WINCHESTER SOUTH PROJECT  
WATER AND FINAL LANDFORM ADDENDUM

JUNE 2023  
Project No. WHC-18-62  
Document No. 01185344-006.docx

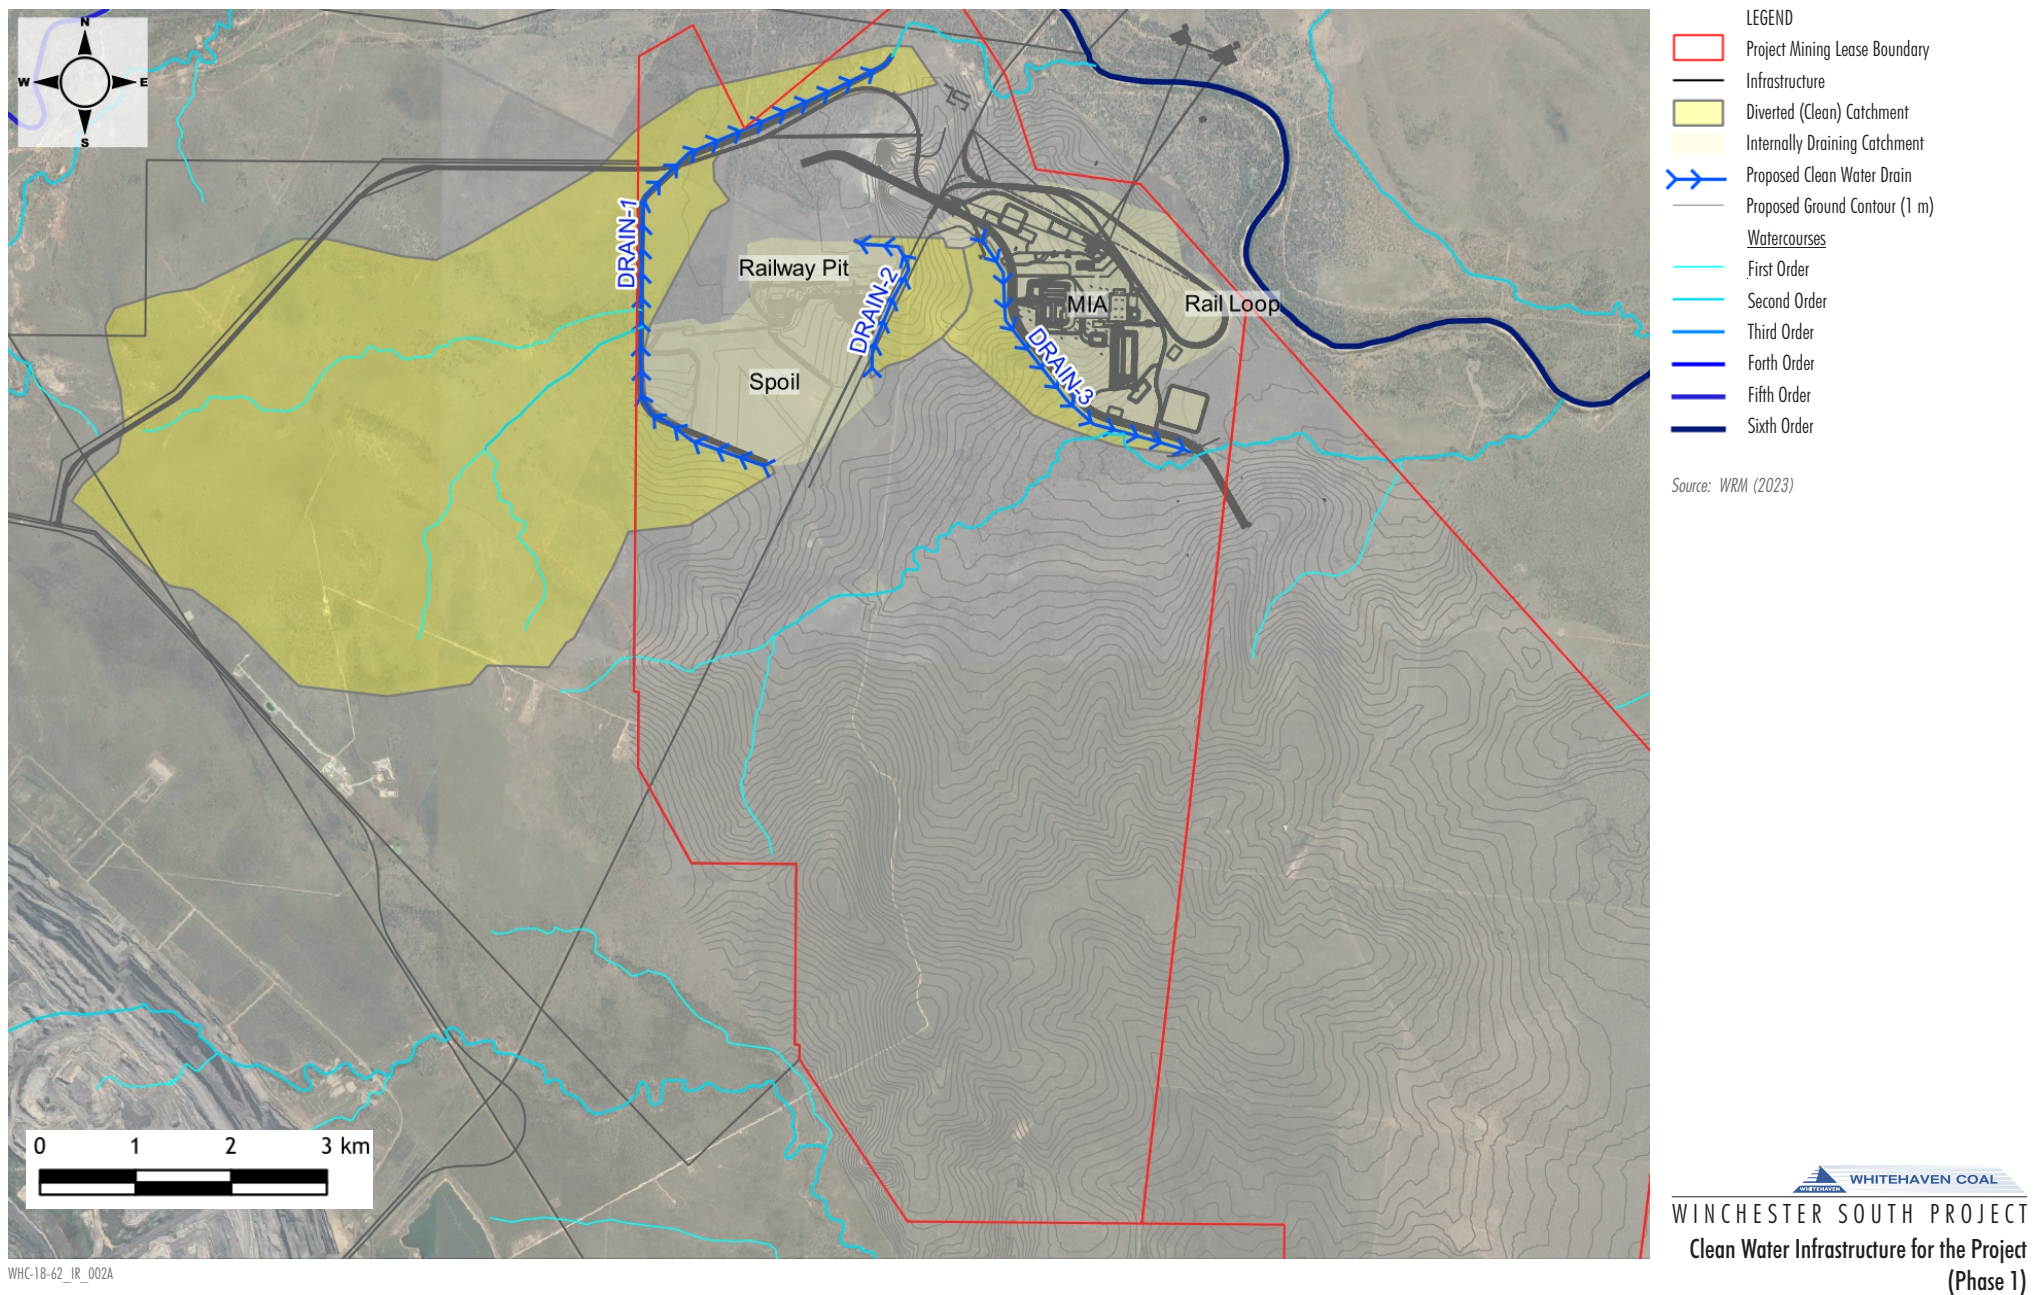
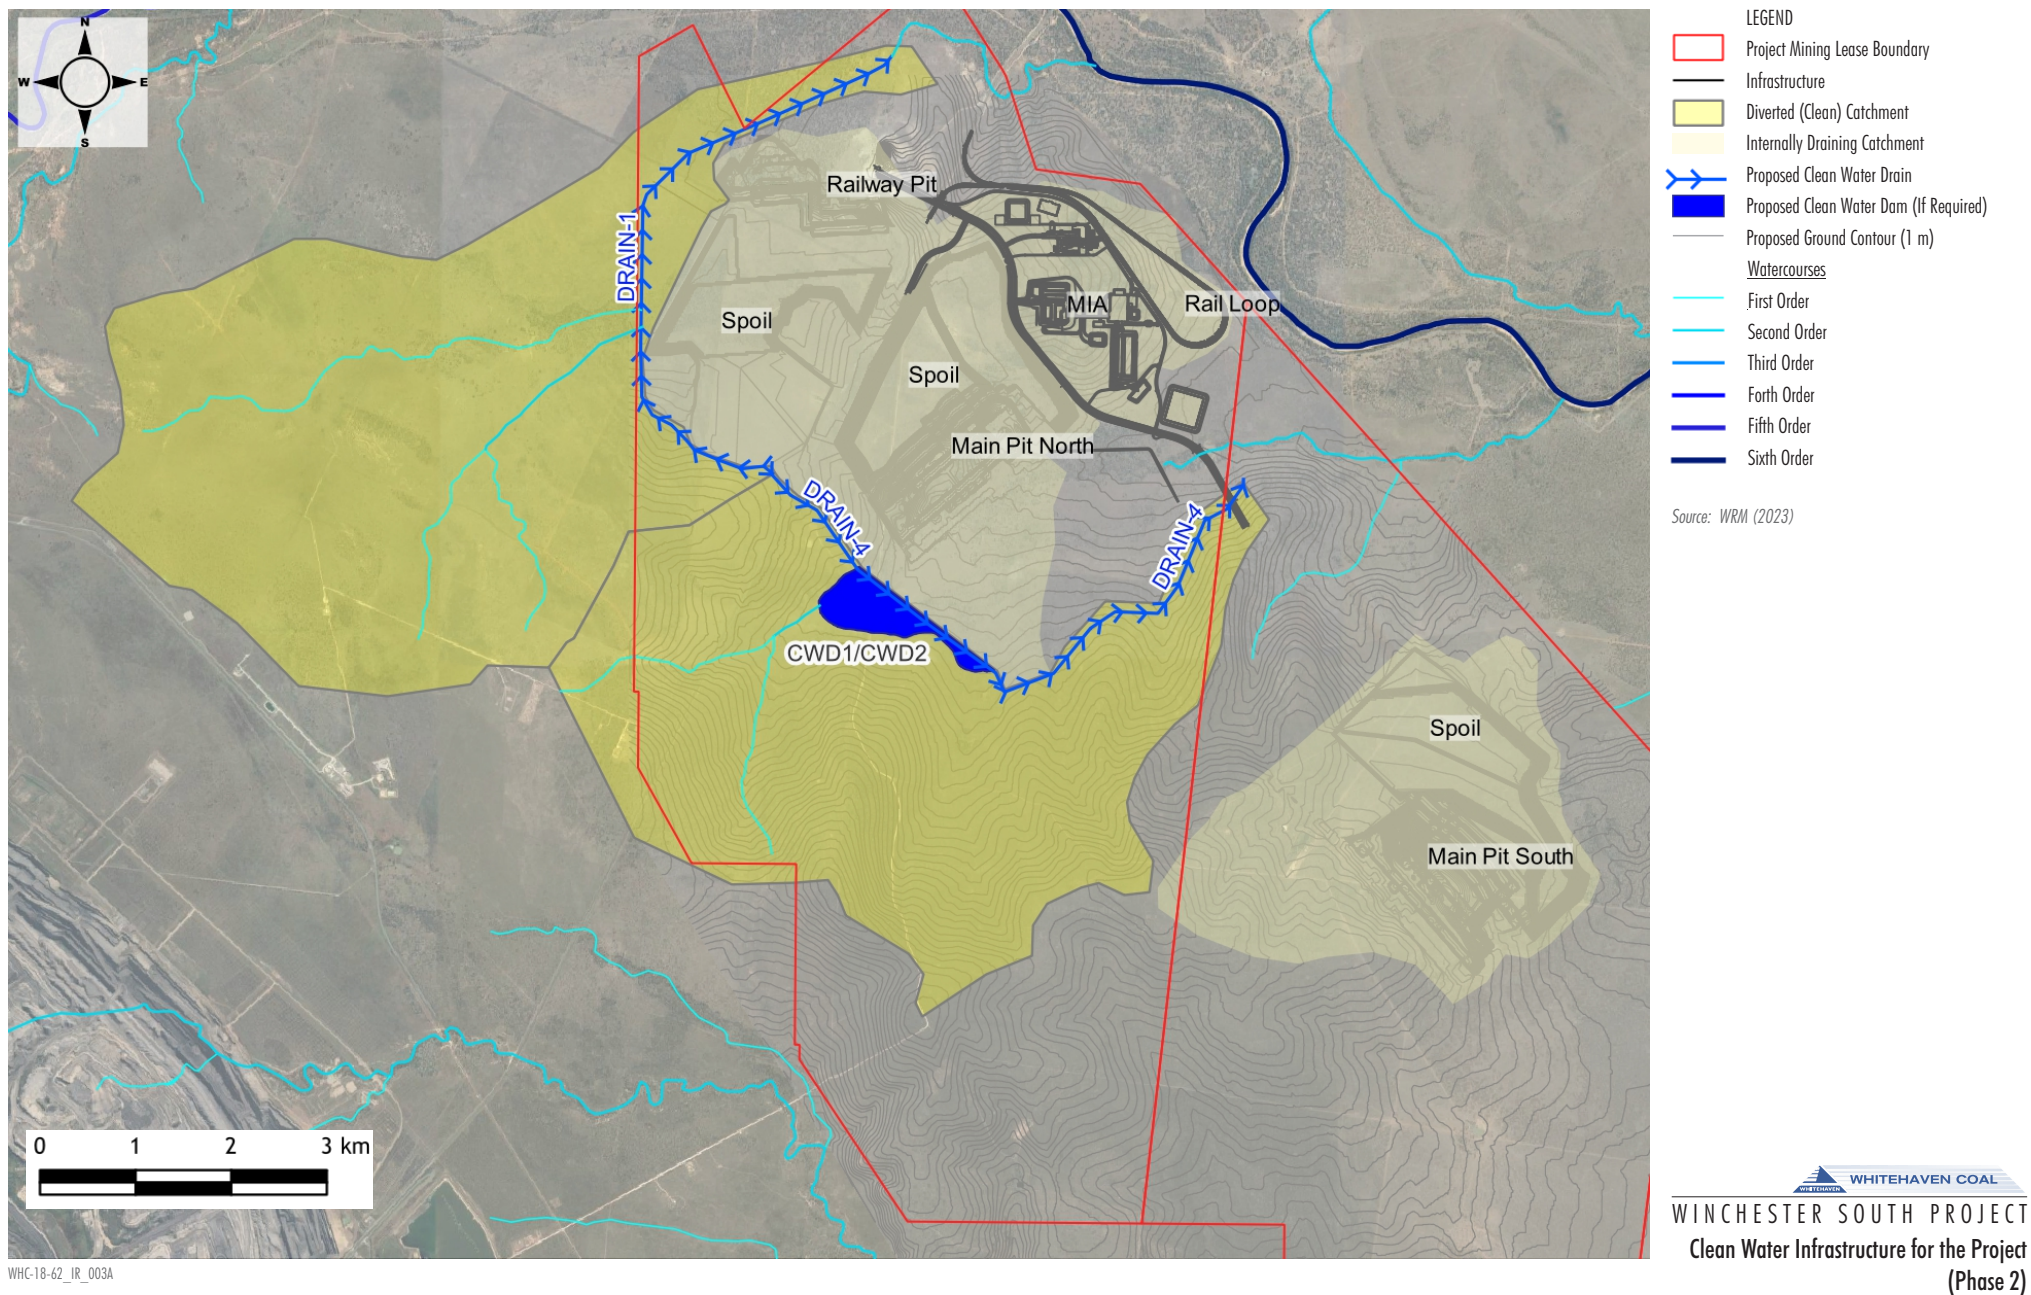
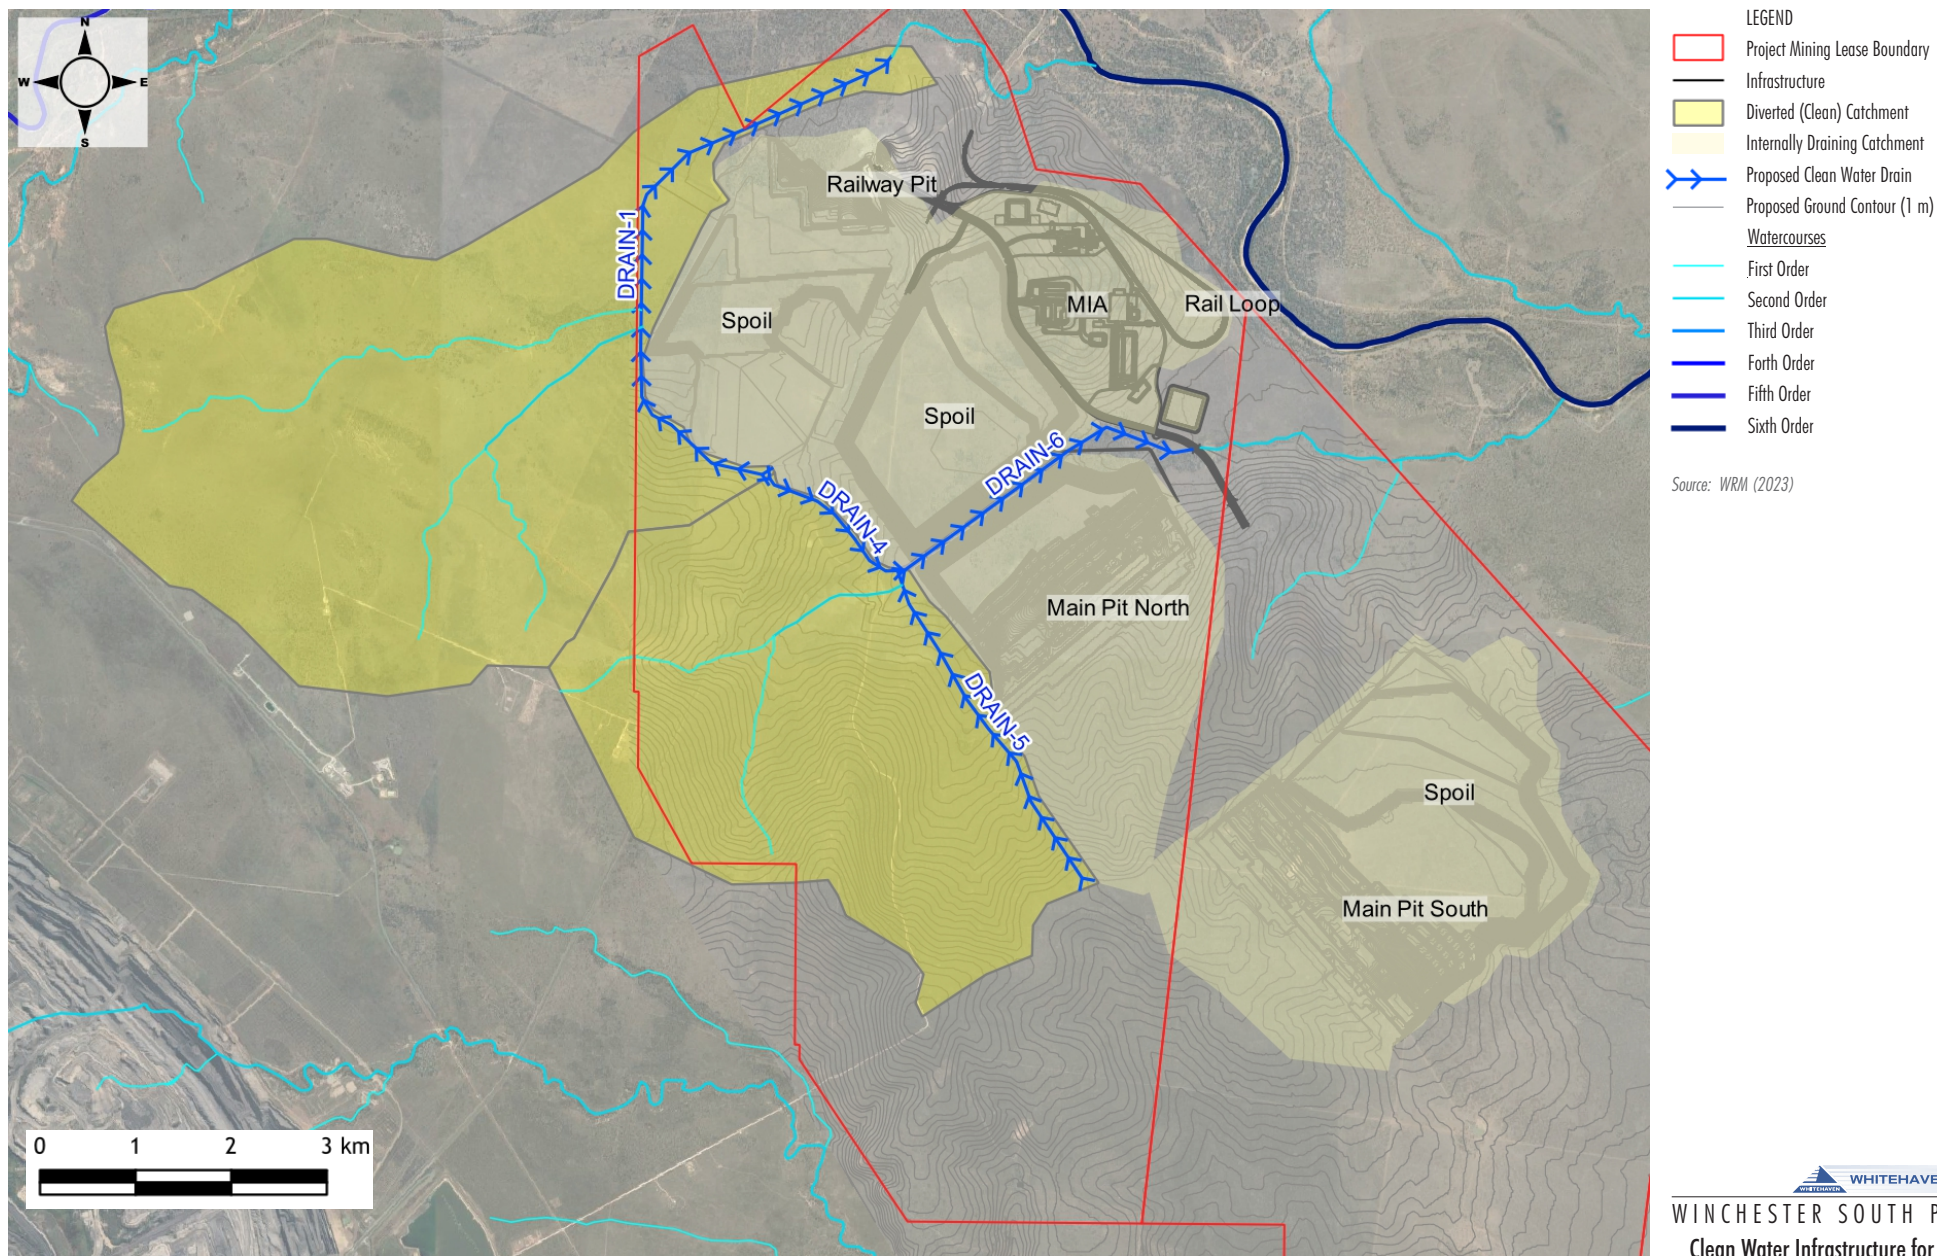
Section 2.7 (water management) of the project description lists CWD 1 and 2 as proposed water storages, and shows CWD 1 on Figure 2-5.

Clean Water Dams (CWD) 1 and 2 are shown in the DEIS SWFA on figures 5.3, 5.4 (proposed water management system) and Figure 6.2 (water management system schematic), and Table 6.5 where CWD 1 has a design storage volume (DSV) of 26ML and a total storage volume (TSV) of 523ML, and CWD 2 has a DSV of 56ML and TSV of 1,121ML. CWD 1 and 2 will impound flows related to the unnamed central waterway.

The size and operation of the clean water dams was raised in a submission on the DEIS from DRDMW (DEIS issue 452.03). The submission noted that the dams proposed to capture overland flow had a maximum capacity greater than 50ML, and under section 110, 2(b) of the Water Plan (Fitzroy Basin) 2011 would require a water licence under the Water Act 2000.

Section 5.6.1 of RDEIS Attachment 6 (SWFA) has removed reference to CWD 1 and 2 in text and figures and now states: Whitehaven WS may implement alternative clean water diversions over the life of the Project to divert water around active operations. This could potentially include diversions/embankments that are located further upslope than the indicative locations shown on Figure 5.1 to Figure 5.6 (within the proposed Project footprint) and/or clean water dams and associated pumping infrastructure.

In response to DES issue 584.32 on the RDEIS, the following direction to the proponent was given: Provide a detailed description of the design and location of clean water management system (including waterway diversions) to ensure all relevant potential impacts are identified and adequately assessed.

Whitehaven's response to this issue referred to four dams in the MIA (in the context of another section of the direction to proponent around MAW storage capacities) and conditions F29 and F30 which relate to the water management plan. No further details of the clean water management systems are provided.

In response to DES issue 584.83 the following direction to the proponent was given: Provide a revised list of draft EA conditions and the required management approach that includes details of temporary and permanent disturbance of water flow paths/patterns, including levees, regulated structures and other water management infrastructures such as diversions. Provide maps at suitable scale for all locations.

A series of up-catchment clean water drains are proposed to temporarily divert clean runoff water around the active mining areas. The indicative locations of the clean water drains for the various phases of the Project are shown on Figure 3-1A to Figure 3-1F. Diverting clean water around the mining areas has multiple benefits to operations and the receiving environment (compared with capturing all up-catchment runoff), namely:

Alternative clean water management strategies and infrastructure may be implemented over the life of the Project to divert water around active operations. This could potentially include development of additional drains/embankments as required. Detailed design of water management infrastructure would be outlined in the Water Management Plan for the Project and updated over the life of the Project. As described above, the indicative locations of clean water drains are shown in Figure 3-1A to Figure 3-1F. The drainage pathways for the rehabilitated final landform are shown on Figure 3-1G.

- Project Year 1 to Project Year 6 (Phase 1) operations shown in Figure 3-1A:
  - A clean water drain (DRAIN-1) diverts clean runoff around the south and west of the Railway Pit.
  - A clean water drain (DRAIN-2) diverts clean runoff around the east of the Railway Pit mining area.
  - A clean water drain (DRAIN-3) diverts clean runoff around the south of the Mine Infrastructure Area.
- Project Year 7 to Project Year 11 (Phase 2) operations shown in Figure 3-1B:
  - DRAIN-1 remains, diverting clean runoff around the south and west of the Railway Pit.
  - DRAIN-2 is removed as part of mining activities.
  - A clean water drain (DRAIN-4) diverts clean runoff around the south and east of the Main Pit North.
  - DRAIN-3 is removed as part of mining activities.
  - A clean water dam (CWD1/CWD2) (if required) temporarily holds clean runoff diverted via DRAIN-4.

- Project Year 12 to Project Year 16 (Phase 3) operations shown in Figure 3-1C:
  - DRAIN-1 remains, diverting clean runoff around the south and west of the Railway Pit.

- CWD1/CWD2 (if required) is removed as part of mining activities.
- Project Year 17 to Project Year 21 (Phase 4) operations shown in Figure 3-1D:
  - DRAIN-1 remains, diverting clean runoff around the south and west of the Railway Pit.

- A clean water (DRAIN-7) diverts clean runoff around the south of the out-of-pit emplacement, draining south towards a tributary of Ripstone Creek.
- Project Year 22 Project Year 26 (Phase 5) operations shown in Figure 3-1E:

- DRAIN-7 remains, draining south towards a tributary of Ripstone Creek.
- Project Year 27 to Project Year 29 (Phase 6) operations shown in Figure 3-1F:
